December 16, 2015
RC-15-0171

Subject: VIRGIL C. SUMMER NUCLEAR STATION, UNIT 1
DOCKET NO. 50-395
OPERATING LICENSE NO. NPF-12
LICENSE AMENDMENT REQUEST – LAR-15-01424
IMPLEMENTATION OF WCAP-15376-P-A, REVISION 1 – “RISK-INFORMED
ASSESSMENT OF THE RTS AND ESFAS SURVEILLANCE TEST
INTERVALS AND REACTOR TRIP BREAKER TEST AND COMPLETION
TIMES”

The proposed changes will revise TS 3/4.3.1, "Reactor Trip System Instrumentation," and TS 3/4.3.2, "Engineered Safety Feature Actuation System Instrumentation," to implement the Allowed Outage Time, Bypass Test Time, and Surveillance Frequency changes approved by the NRC in WCAP-15376-P-A, Rev. 1, "Risk-Informed Assessment of the RTS and ESFAS Surveillance Test Intervals and Reactor Trip Breaker Test and Completion Times," dated March 2003. The proposed changes in this license amendment request are consistent with the NRC approved Technical Specification Task Force (TSTF) Improved Standard Technical Specification Change Traveler TSTF-411, Rev. 1, "Surveillance Test Interval Extensions for Components of the Reactor Protection System (WCAP-15376-P)." These changes will also result in a revision to the TS Bases for 3/4.3.1 and 3/4.3.2, "Reactor Tr

REACTOR TRIP SYSTEM INSTRUMENTATION SURVEILLANCE REQUIREMENTS

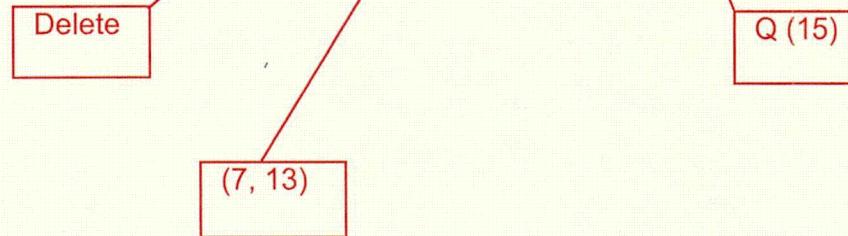
2.3 TS 3/4.3.1, Table 4.3-1 –TADOT – The proposed change to the TADOT for the Reactor Trip Breaker (Function 20) is from Monthly (62 days on a Staggered Test Basis) to every 2 months (124 days on a Staggered Test Basis) as shown in revised Note 7. Note because of the difference in the Staggered Test Basis definition (discussed above) the number of days used for the VCSNS surveillance frequency is larger than the number used in TSTF-411 surveillance frequency.

2.4 TS 3/4.3.1, Table 4.3-1 – TADOT – The proposed change to the TADOT for the Reactor Trip Bypass Breaker (Function 22) is from Monthly (62 days on a Staggered Test Basis) to every 2 months (124 days on a Staggered Test Basis) as shown in revised Note 7 (62 days to 124 days), which is being inserted into the TADOT column. Note that this change is different than what is shown in the markups for TSTF-411. This change is necessary because TSTF-411 does not provide a change to the Reactor Trip Bypass Breaker as the Bypass Breaker is treated as a part of the Reactor Trip Breaker function in the standard TS in NUREG-1431 and has the same surveillance frequency assigned. In the VCSNS TS the Reactor Trip Breakers and the

2.5 TS 3/4 3.1, Table 4.3-1 – Actuation Logic Test (ALT) – The proposed change to the ALT for the Automatic Trip Logic (Function 21) is from Monthly to Quarterly on a Staggered Test Basis as specified in new Note 15 (184 days).

(16) - 12 hours after reducing power below P-10 and 184 days thereafter.

ENGINEERED SAFETY FEATURE ACTUATION SYSTEM INSTRUMENTATION
SURVEILLANCE REQUIREMENTS

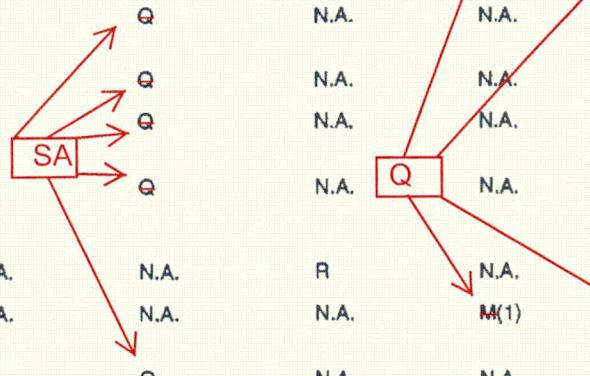
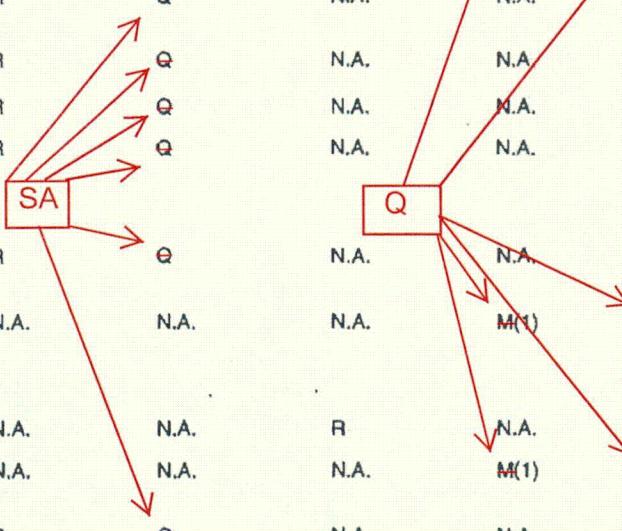
2.6 TS 3/4.3.2, Table 4.3-2 – ACOT - The proposed change to the ACOT is from Quarterly to Semi-Annually for the following functions in Table 4.3-2 of the VCSNS TSs: 1.c, 1.d, 1.e, 1f, 2.c, 3.b.2, 4.c, 4.d, 4.e, 5.a, 6.c, 6.h, 8.a, 9.a, and 9.b (see Attachment 1 TS mark-up for the title of each Function).

2.7 TS 3/4.3.2, Table 4.3-2 – ALT – The proposed change to the ALT is from Monthly to Quarterly on a Staggered Test Basis as shown in the revised Note 1 (62 days to 184 days) for the following functions in Table 4.3-2 of the VCSNS TSs: 1.b, 2.b, 3.a.3, 3.b.1, 3.c.1, 4.b, 5.b, 6.b, and 8.b (see Attachment 1 TS mark-up for the title of each function).

2.8 TS 3/4.3.2, Table 4.3-2 – Master Relay Test – the proposed change to the Master Relay Test is from Monthly to Quarterly on a Staggered Test Basis as shown in the revised Note 1 (62 days to 184 days) for the following functions in Table 4.3-2 of the VCSNS TSs: 1.b, 2.b, 3.a.3, 3.b.1, 3.c.1, 4.b, 5.b, 6.b, and 8.b (see Attachment 1 TS mark-up for the title of each function).
